| <b>ITEM #6.3:</b> | <b>COMMITTEE OF ADJUSTMENT REPORT</b><br><b>MINOR VARIANCE APPLICATION</b><br><b>A237/22</b><br><b>43 Muzich Pl Woodbridge</b> |

**COMMITTEE OF ADJUSTMENT REPORT**  
**MINOR VARIANCE APPLICATION**  
**A237/22**  
**43 Muzich Pl Woodbridge**

| <b>PURPOSE OF APPLICATION:</b>                   | Relief from the Zoning By-law is being requested to permit reduced lot area on the <b>retained land</b> to facilitate Consent Application B015/22. Relief is also being requested to permit the construction of a proposed single family dwelling and cabana and increased maximum driveway width on the <b>retained land</b> . |

Severed Site Plan

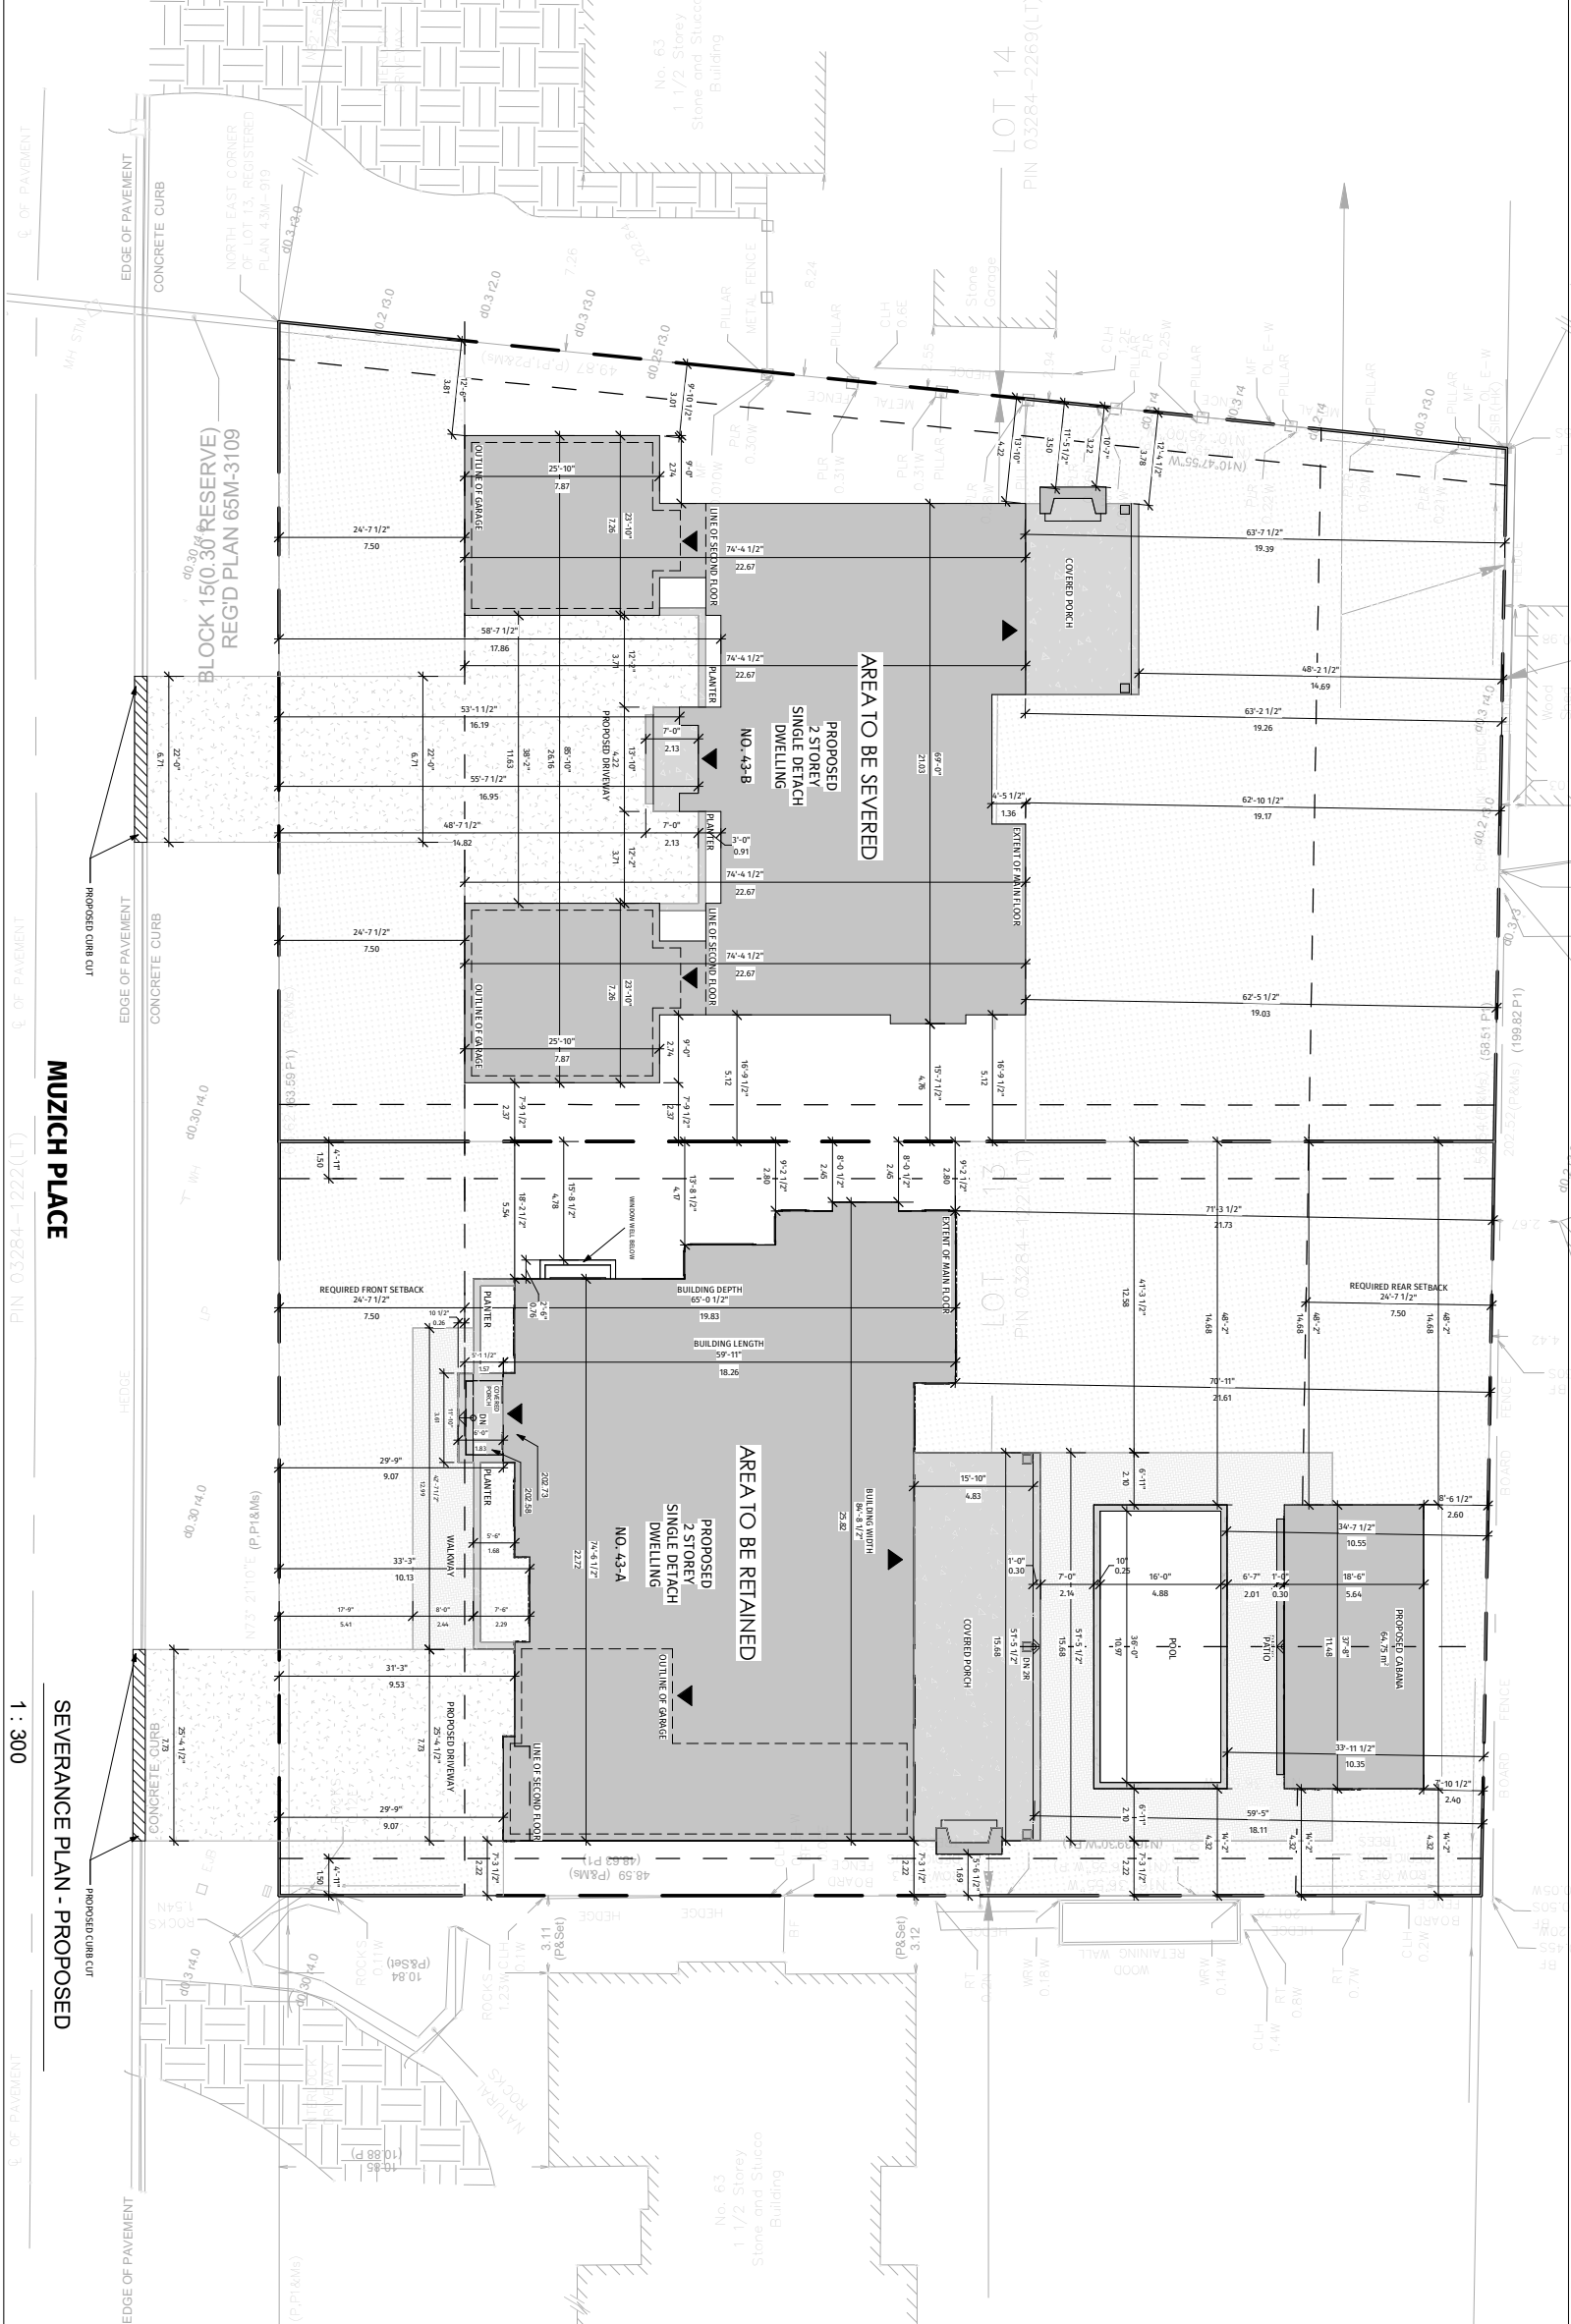
The Development Planning Department has no objection to Variances 3 and 7 as the proposed lot area respects the existing lotting fabric of the neighbourhood and is similar to the existing lots along the south side of Muzich Place and Orr Avenue.

The Development Planning Department has no objection to Variances 2 and 8 as the proposed lot area respects the existing lotting fabric of the neighbourhood and is similar to the existing lots along the south side of Muzich Place and Orr Avenue.

## Cabana Plans

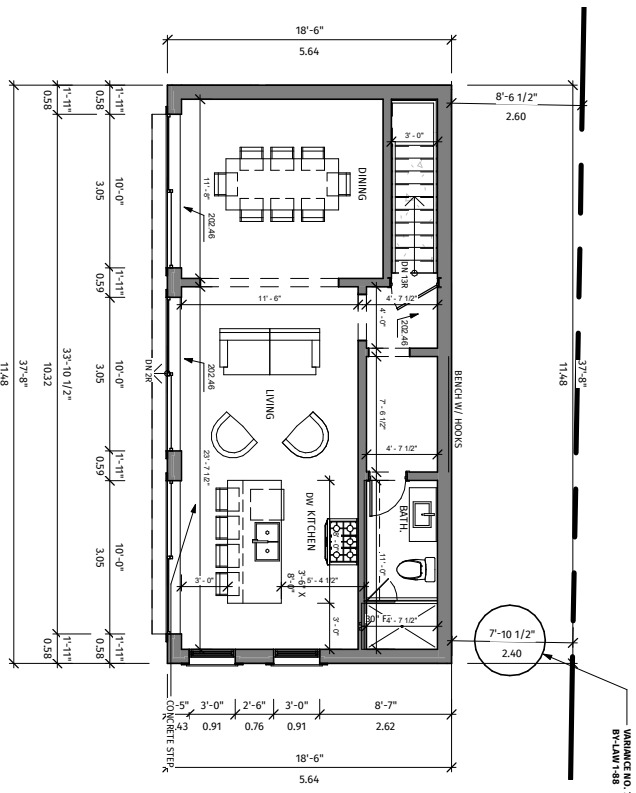
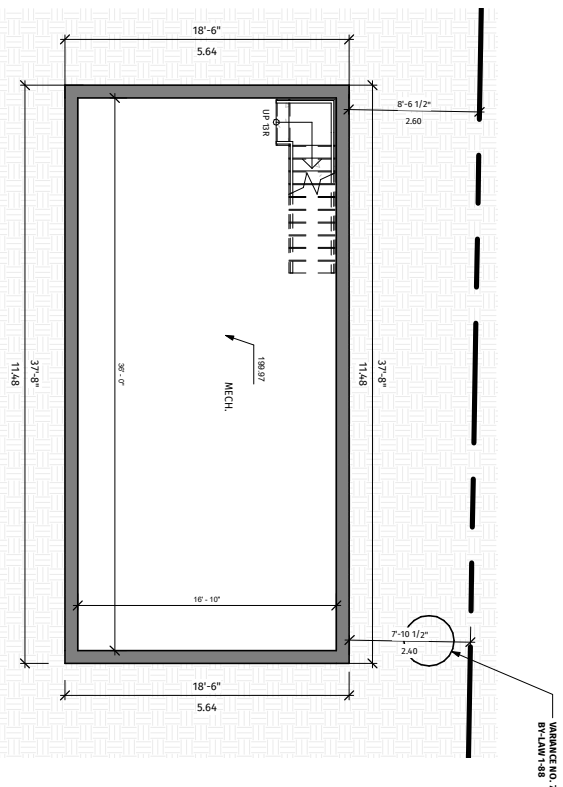
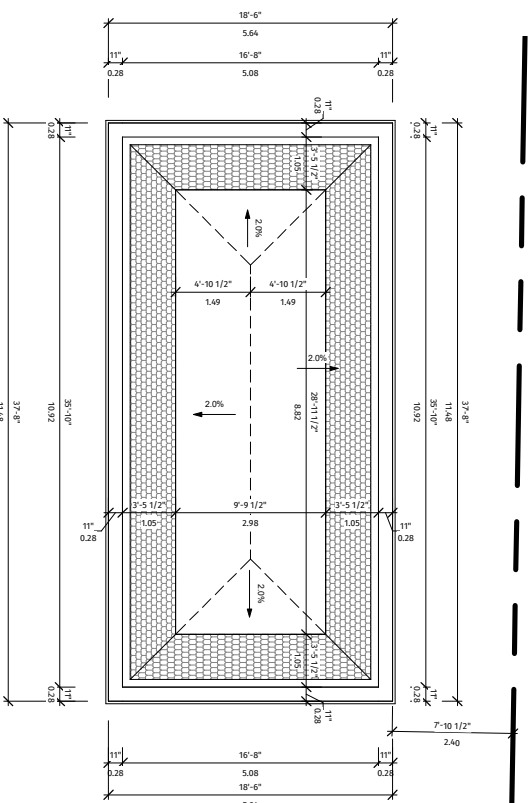
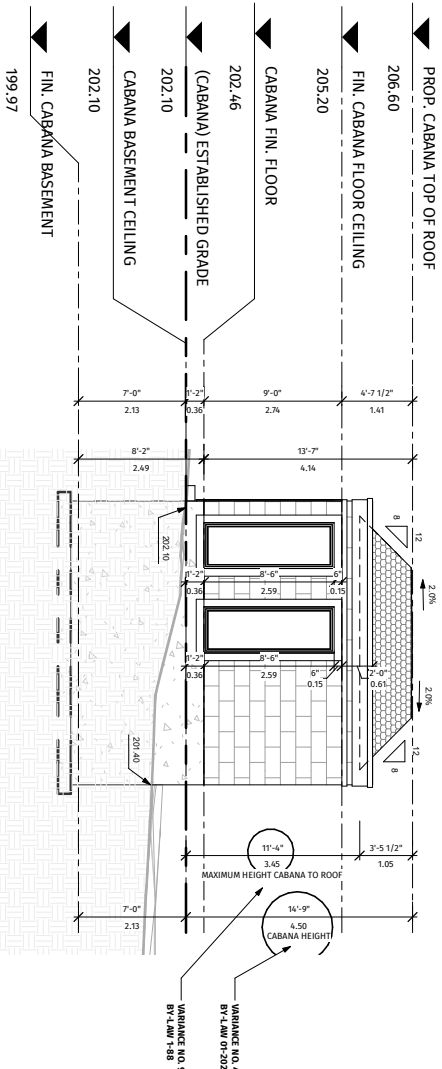
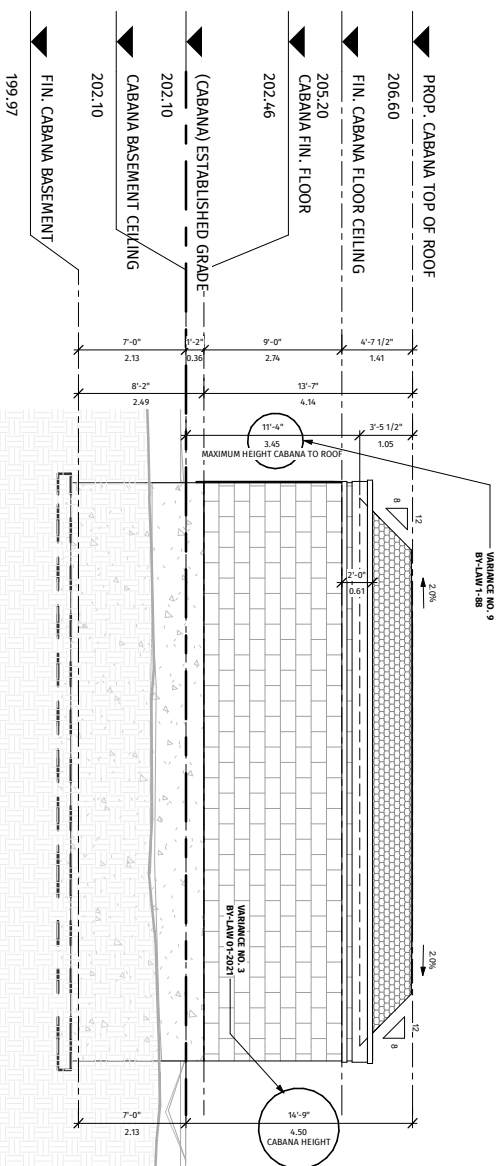
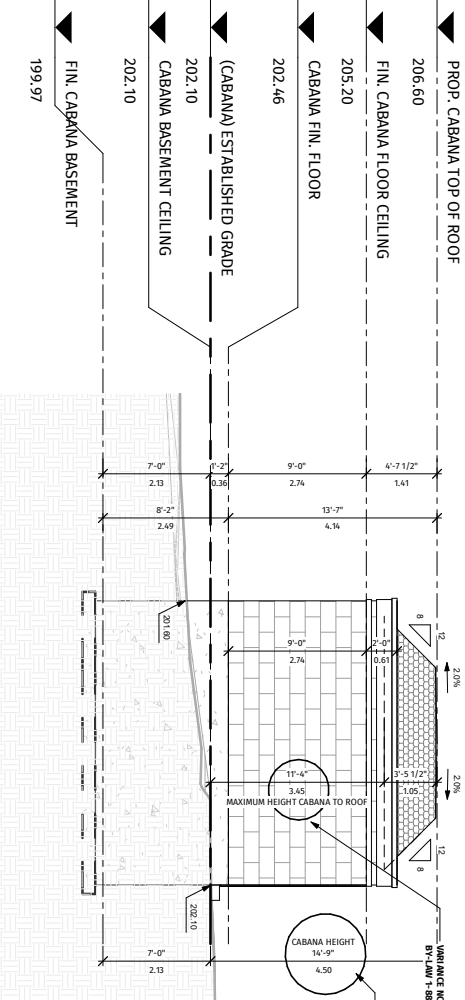
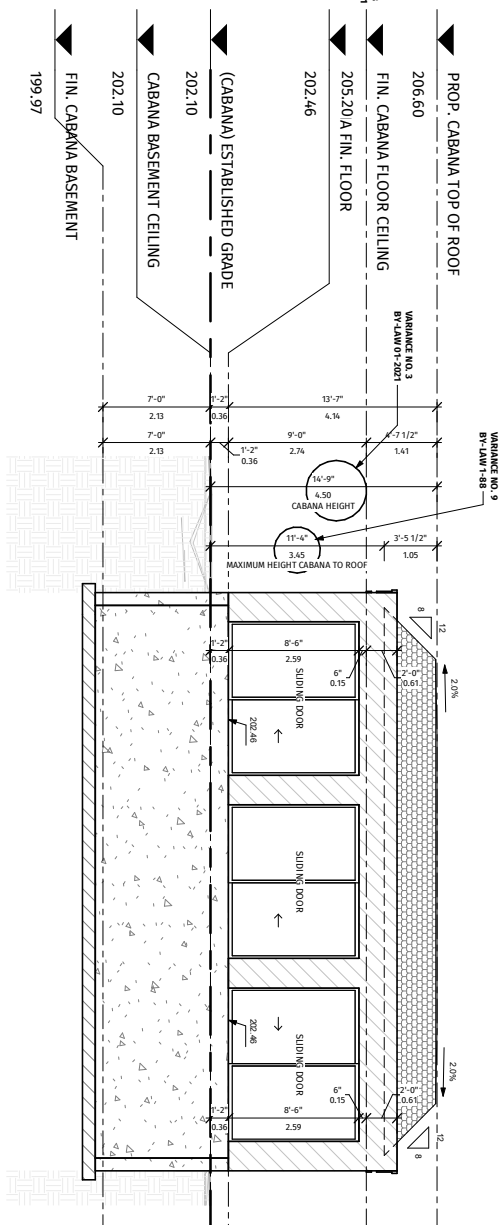
Upon recommendations from the Development Planning Department, the Owner has revised their application by increasing the rear yard setback and reducing the height of the proposed cabana. The Development Planning Department has no objection to Variances 3, 7 and 9 for the revised cabana. The height of the cabana is in line with previous approvals in the neighbourhood and the rear yard setback now complies with Zoning By-law 001-2021. The Owner will be providing vegetative buffering to the rear of the cabana to further screen the cabana from the neighbouring properties. A condition to this effect is recommended in the Condition of Approval. With the establishment of vegetation, the cabana will not pose adverse massing impacts to the neighbouring properties and an appropriate area for maintenance access is maintained.

1. That the final Arborist Report and Tree Preservation Plan be approved to the satisfaction of the Development Planning Department.
2. That the final Landscape Plan, which shall include plantings between the proposed cabana and rear lot line, be approved to the satisfaction of the Development Planning Department.
